UNITED STATES PATENT AND TRADEMARK OFFICE

APPLICATION NO.	FILING DATE	FIRST NAMED INVENTOR	ATTORNEY DOCKET NO.	CONFIRMATION NO.
10/820,401	04/08/2004	Stylios Panaghe	7579	8464

Office Action Summary	Application No. 10/820,401	Applicant(s) PANAGHE, STYLIANOS	
	Examiner John A. Jeffery	Art Unit 3742

DETAILED ACTION

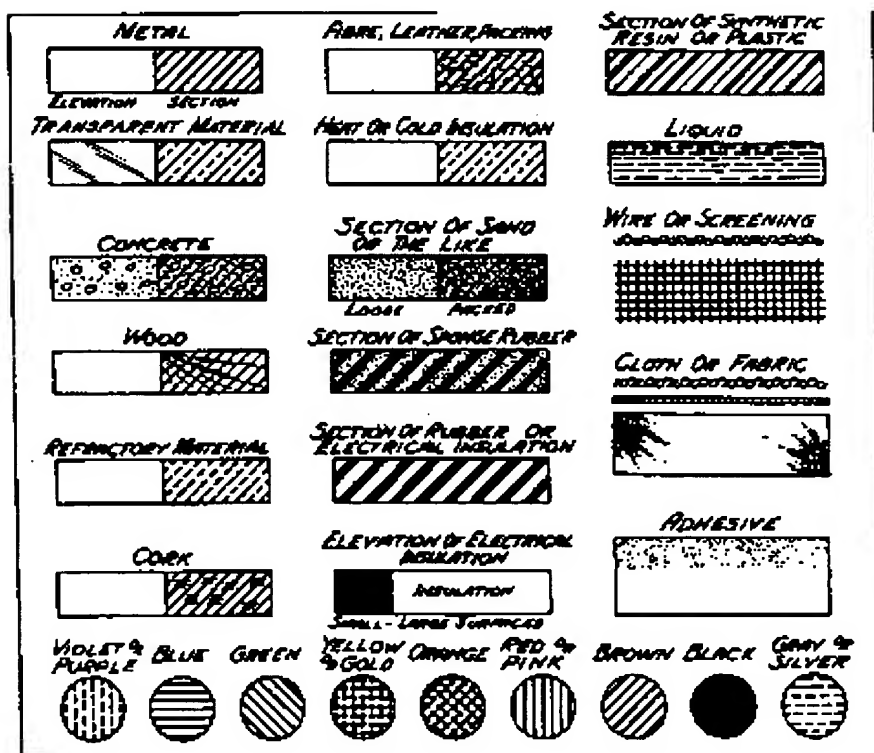
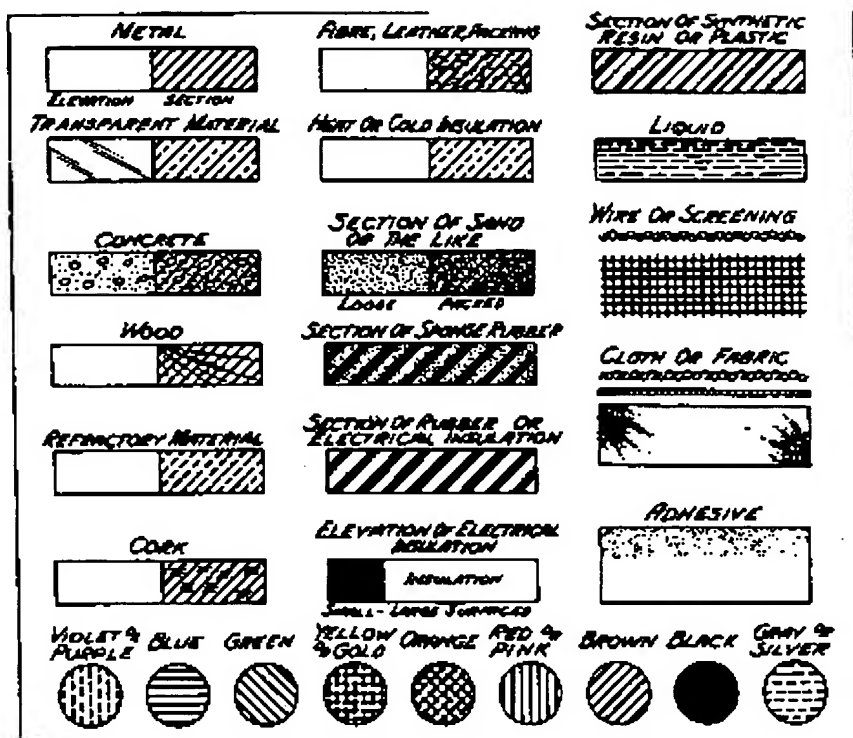
Fig. 1 and 2: Proper cross-sectional hatching is required to properly denote insulative materials for (1) ceramic tracks 3 and 4, and (2) dielectric layer 6 in accordance with MPEP 608.02 (see the drawing below for proper hatching examples). The layers are currently incorrectly hatched for metal.

Applicant must also enlarge Fig. 2 for clarity so that proper hatching is legible within each layer's thickness.
